NUCLEAR UTILITY GROUP
ON EQUIPMENT QUALIFICATION

Enclosed please find a Nuclear Utility Group on Equipment Qualification (NUGEQ) document on Limatorque actuator environmental qualification. The document has been prepared by the Group based on our discussions with Limatorque and the contents of the referenced Limatorque reports. The Group requests Limatorque's review and comment on this material.

SUBJECT: Issuance of the NUGEQ Report on Limitorque EQ Clarifications

FIGURE -1

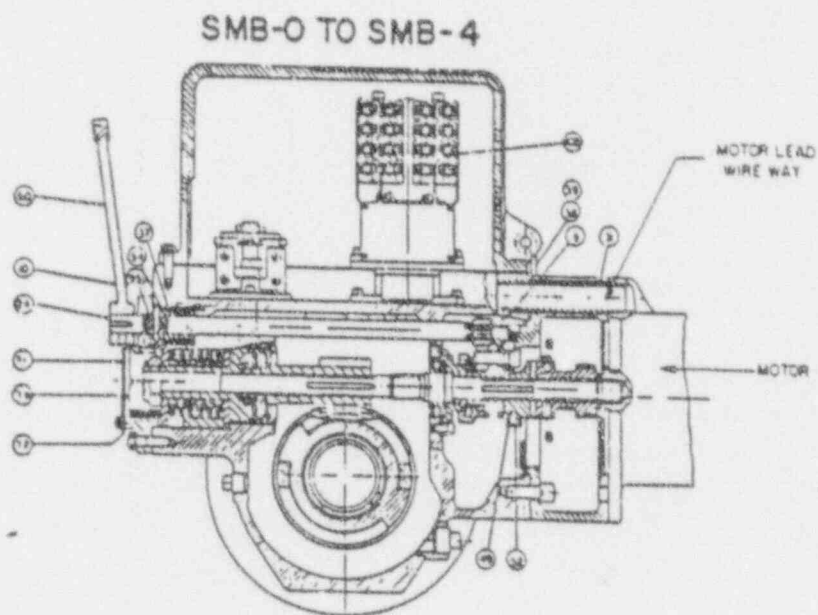
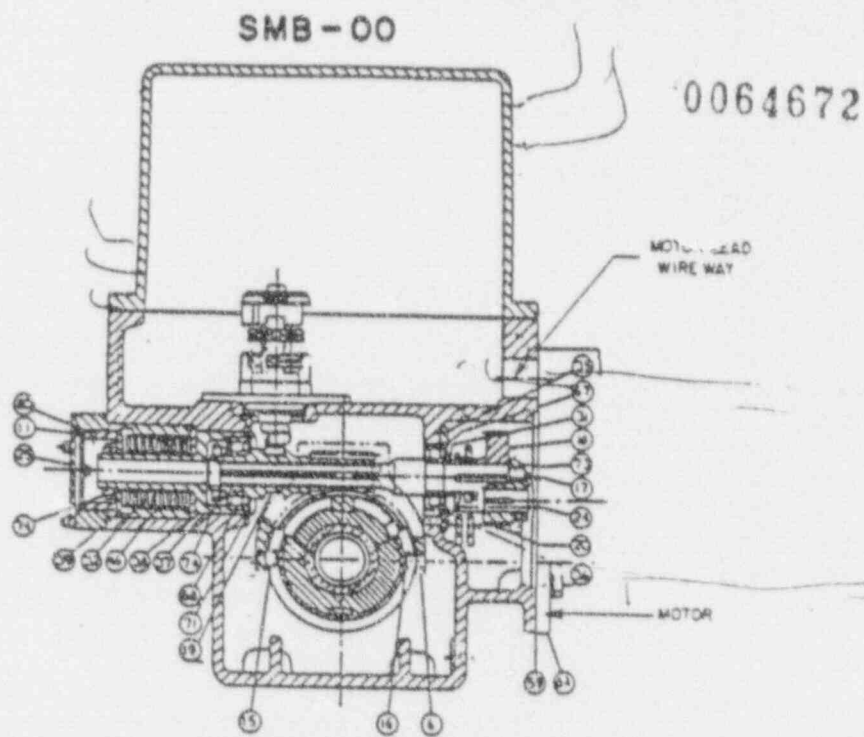
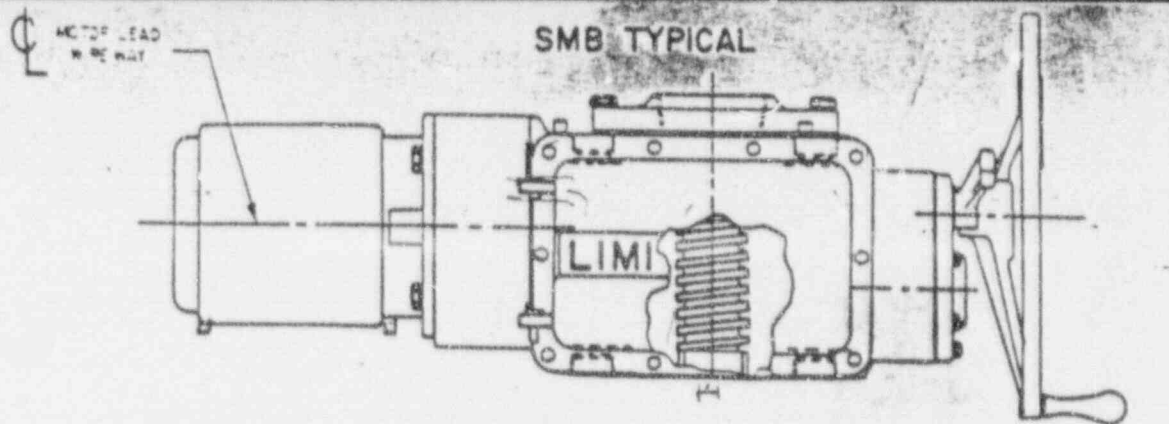
external Limit Switch Compartment (LSC) drains were provided during any of the referenced EQ tests. As previously discussed, for the tested configurations, excess condensation during testing drained from this compartment via the internal wireway into the motor housing. The exact location of the wireway varies with actuator model number (SMB-0, SMB-00, etc.), but is located roughly at 3/4 of the compartment height when the LSC is mounted horizontally. (See Figure 1 attached.)

For installations that reference tests utilizing motor T-drains, Limitorque indicated that the use of LSC drains although not required does not affect qualification since, during the tests, the external environment enter the LCS via the motor T-drains.
